## LAND USE APPLICATION SUMMARY

**Property Location:** 112 Lake Street East  
**Project Name:** 112 Apartments  
**Prepared By:** Andrew Frenz, Senior City Planner, (612) 673-3790  
**Applicant:** James Tindall Jr.  
**Project Contact:** Matt Borowy  
**Request:** To construct a new four-story mixed-use building with 13 dwelling units and approximately 1,600 square feet of commercial space.

1 WEST ELEVATION  
SCALE: 3/16"=1'-0" (LARGE FORMAT)

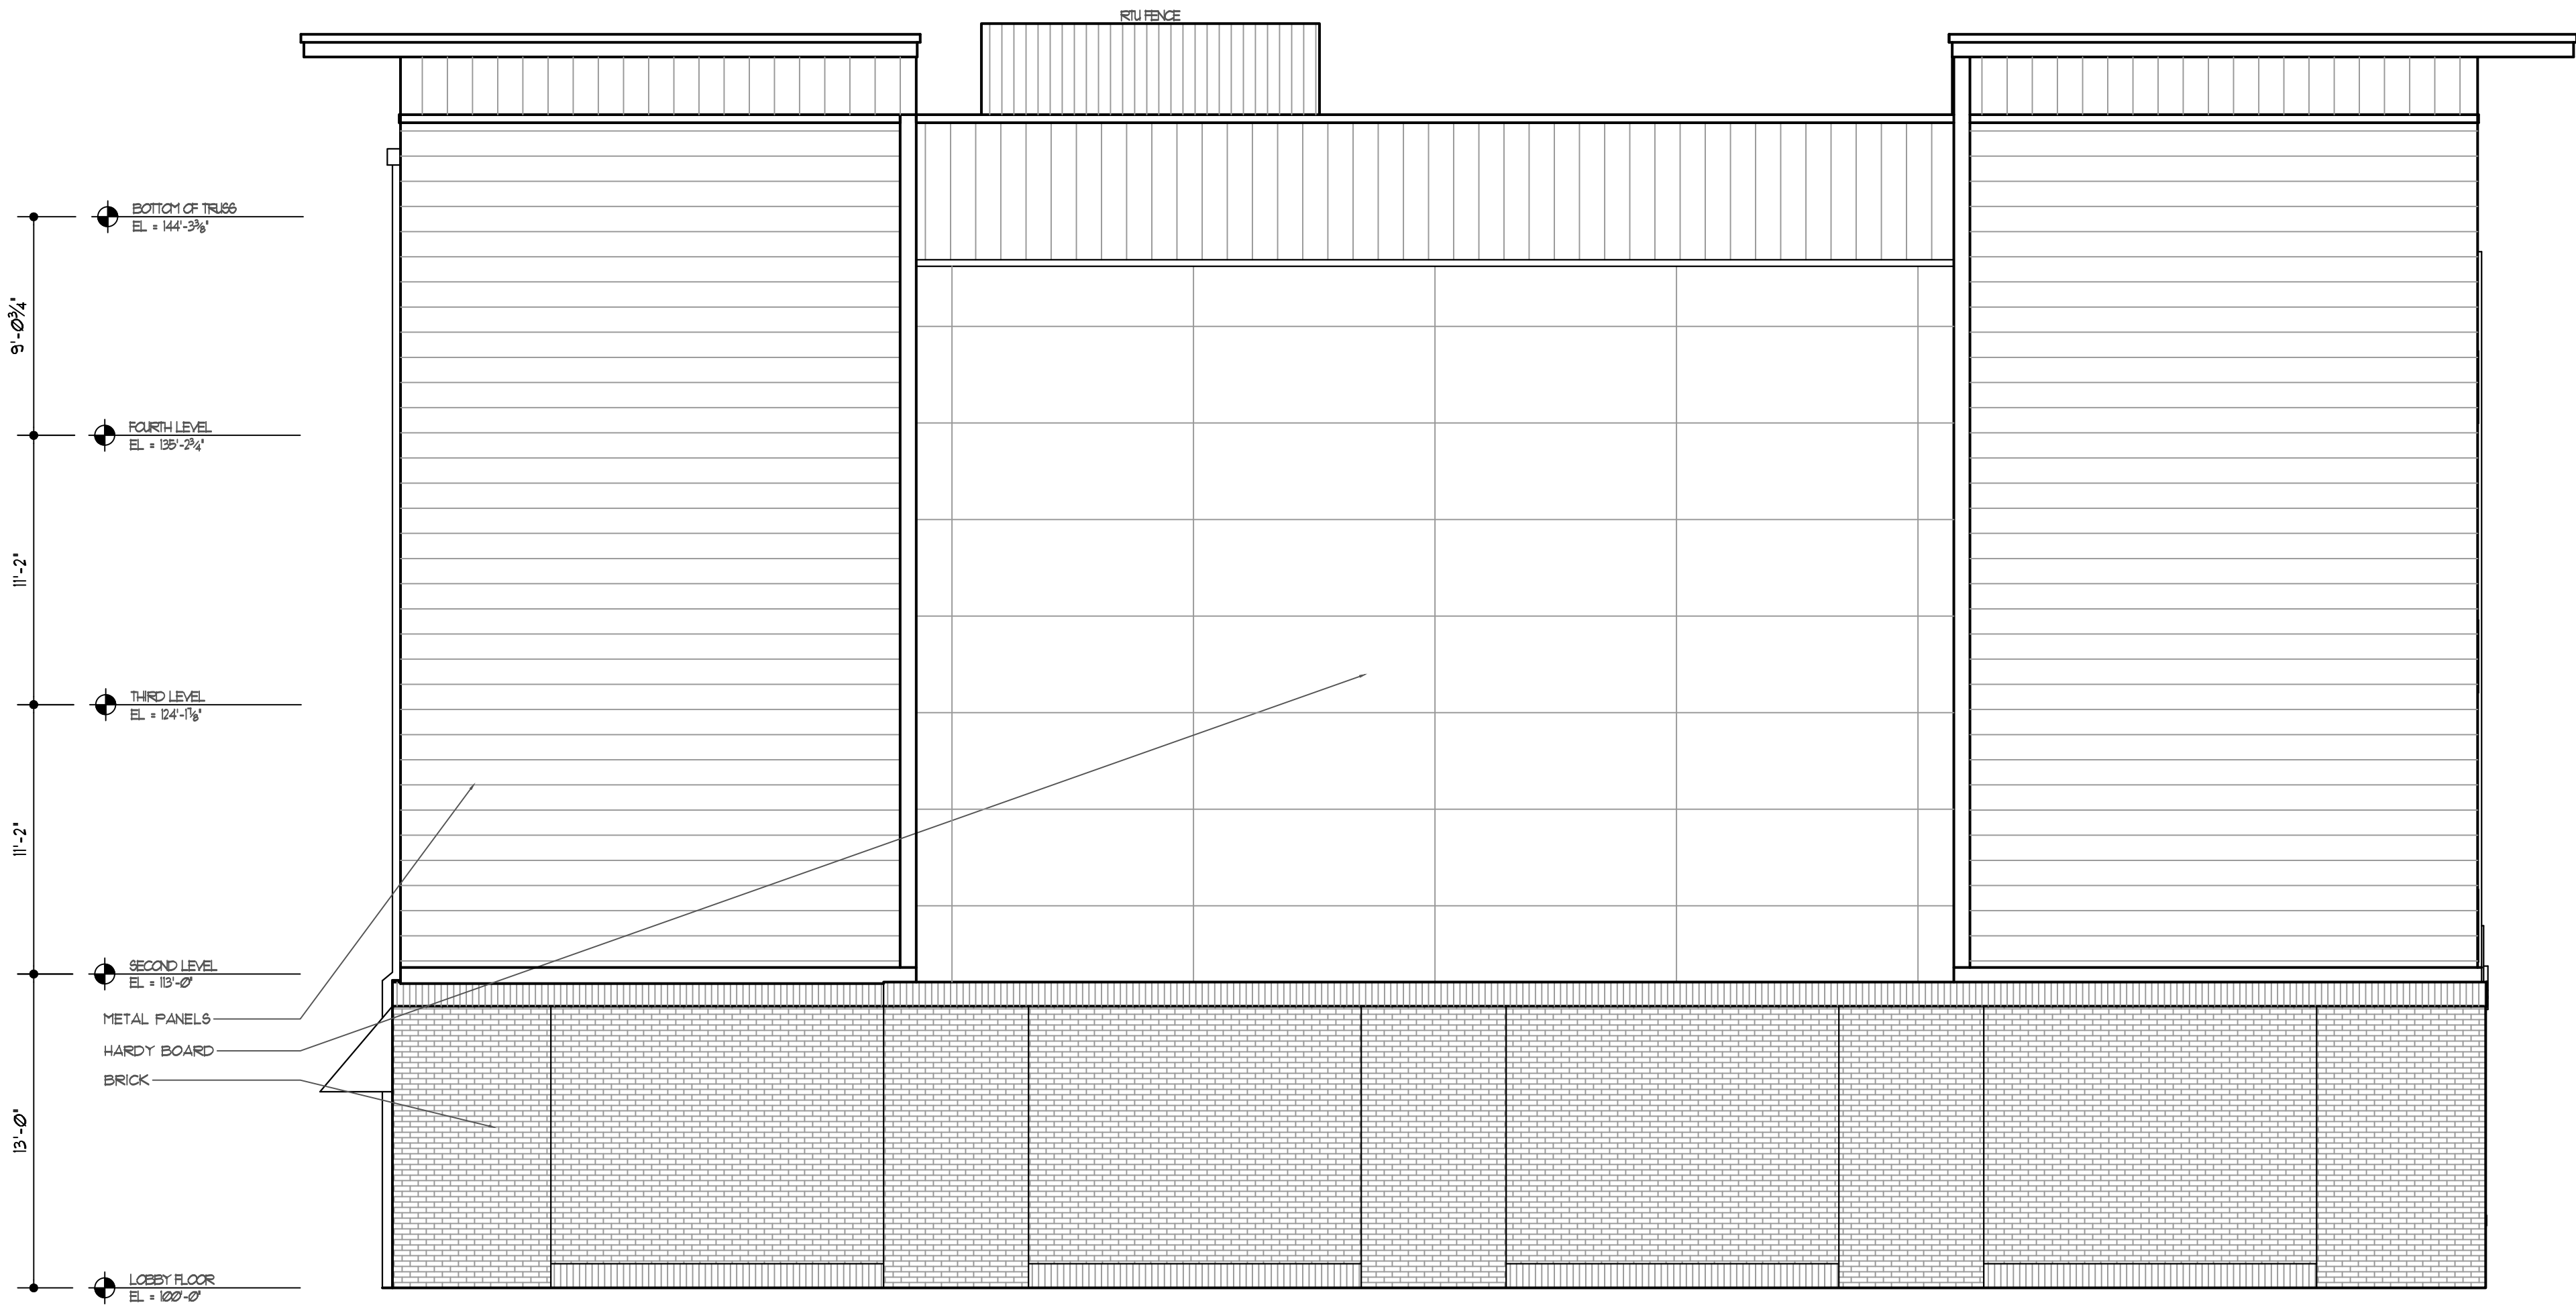
- The building would include blank, uninterrupted walls exceeding 25 feet in length on the west elevation. Alternative compliance is required. On the east elevation, recesses are proposed to break up blank walls, however, the submitted plans do not clearly indicate the depth of the proposed recesses. Staff has recommended as a condition of approval that the proposed brick recesses have a minimum depth of at least two inches to eliminate blank walls.

1. All site improvements shall be completed by November 16, 2022, unless extended by the Zoning Administrator, or the permit may be revoked for non-compliance.
2. CPED staff shall review and approve the final site, elevation, landscaping, and lighting plans before building permits may be issued.
3. All signs shall comply with Chapter 543 of the zoning code. All signage requires a separate permit from CPED.
4. A canopy or awning shall be added above the retail storefront.
5. The proposed brick recesses on the east and west elevations shall have a minimum depth of at least two inches, in accordance with Section 530.120 of the zoning code.
